NORTHERN BEACHES COUNCIL SUPPLEMENTRY ASSESSMENT REPORT

Panel Reference	PPSSNH-155
DA Number	DA2020/1167
LGA	Northern Beaches Council
Proposed Development	Demolition works and Construction of a mixed use development to accommodate a café, church, conference centre, boarding house and two level of basement car park.
Street Address	Part Lot 28 DP 7313, 9 Francis Street and 28 Fisher Road, Dee Why
Applicant/Owner	Baptist Churches of NSW (Owner) The George Group Pty Ltd (Applicant)
Date of DA lodgment	22 September 2020
Number of Submissions	45 submissions which includes: <ul style="list-style-type: none"> • 23 submission in support • 22 submissions in opposition
Recommendation	Refusal
Regional Development Criteria (Schedule 7 of the SEPP (State and Regional Development) 2011	Development with a Capital Investment Value (CIV) of more than \$5 million for affordable housing (which includes a Boarding House)
List of all relevant s4.15(1)(a) matters	<ul style="list-style-type: none"> • Environmental Planning and Assessment Act 1979 • Environmental Planning and Assessment Regulation 2000 • State Environmental Planning Policy No. 55 – Remediation of Land • State Environmental Planning Policy

B3 Side Boundary Envelope

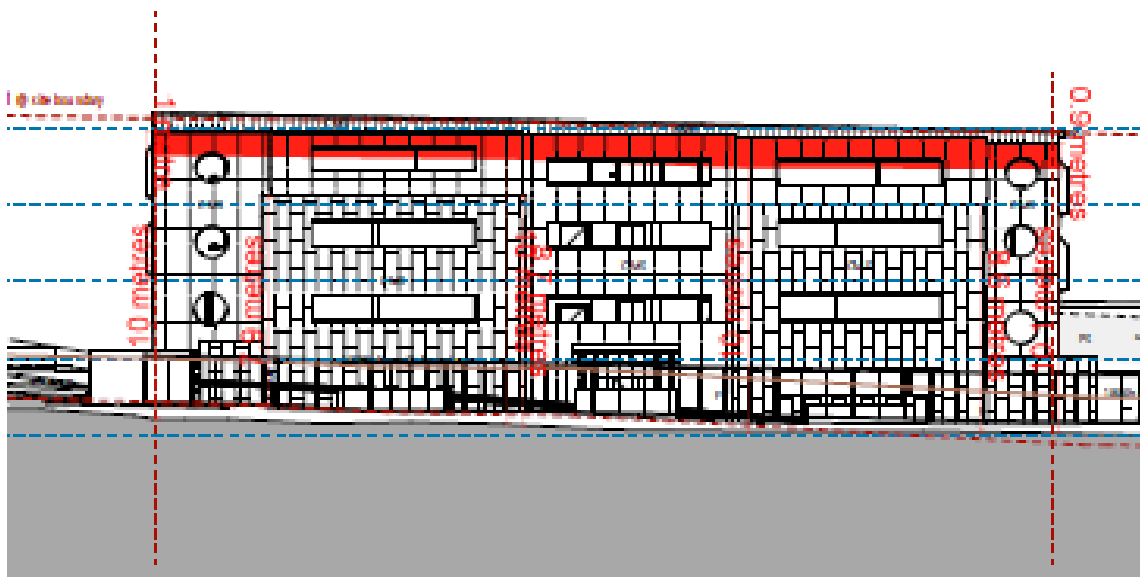
The portion of the development located within the R3 zone results in a non-compliance with the side boundary envelope control, calculated as:

B3 – side Boundary Envelope	5m (north)	Outside Envelope	18% - 36%	No
	5m (south)	Outside Envelope	18%-20%	No

Amended North Elevation showing the side envelope breach in red

Amended south Elevation showing the side envelope breach in red

The extent of the non-compliance as it relates to the southern elevation is improved compared to the original scheme. Despite the amendments, the amended scheme is found to be inconsistent with the objectives of control for the following reasons:

Due to insufficient side setbacks the height, bulk and scale of the development is visually dominate particularly as viewed from the neighbouring properties to the immediate north and south.

Due to inadequate spatial separation between buildings, in particular No. 7 Francis Street to the immediate south, the proposal will result in unreasonable impacts on solar access and privacy.

The proposal does not adequately respond to the topography of the site.

Updated plans LOS Calculation

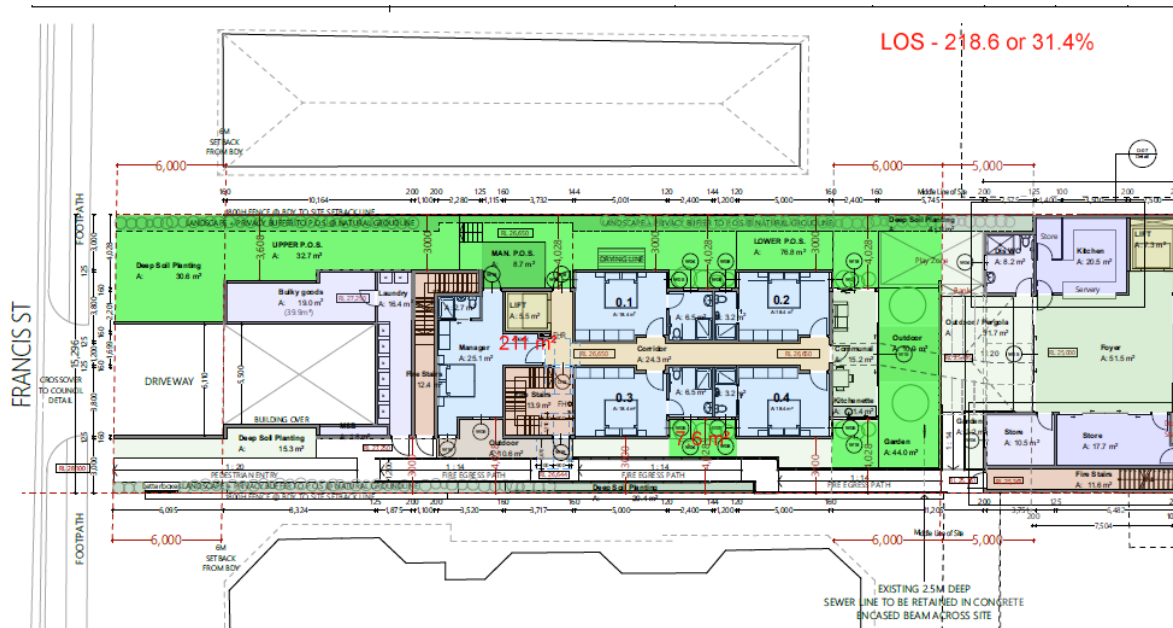
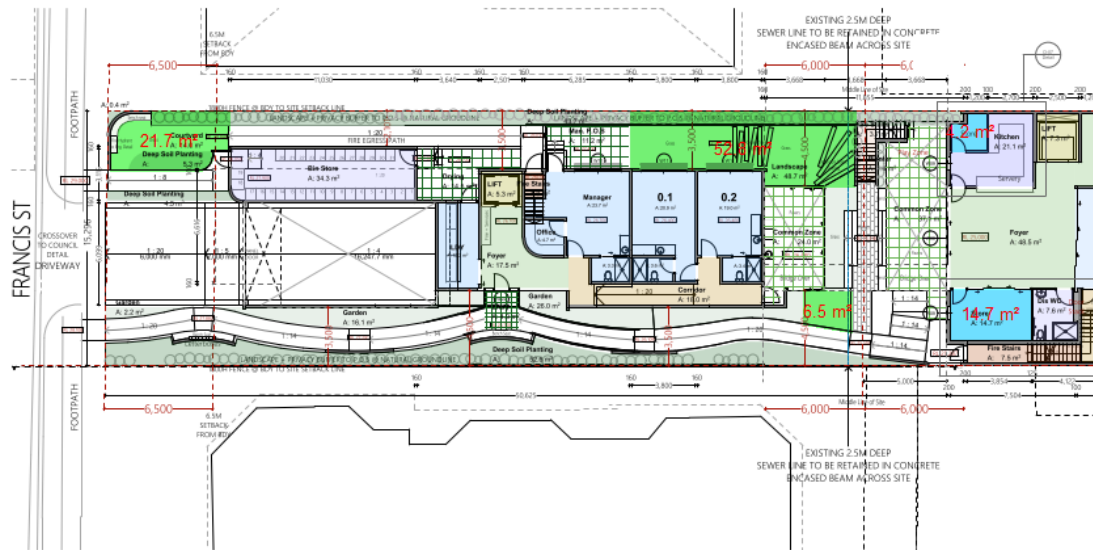
Original working plans LOS

The landscaped area for the R3 site is required to be 40% of 696.6m² (278.24m²), as demonstrated in the diagram above, the amended plans results in a significant reduction landscape open space for the development.

The proposal has been amended to improve the front set back with additional landscaping, including 1m deep soil planting above the bin store area. Although this is improved the overall reduction in terms of landscape open space is worse for the scheme overall.

A compliant 4.5m side set back would allow for additional deep soil zones to allow for the establishment of landscaping that will help mitigate the density, bulk and scale of the building.

The side setbacks restricts the available space for sufficient planting to help mitigate privacy between buildings.
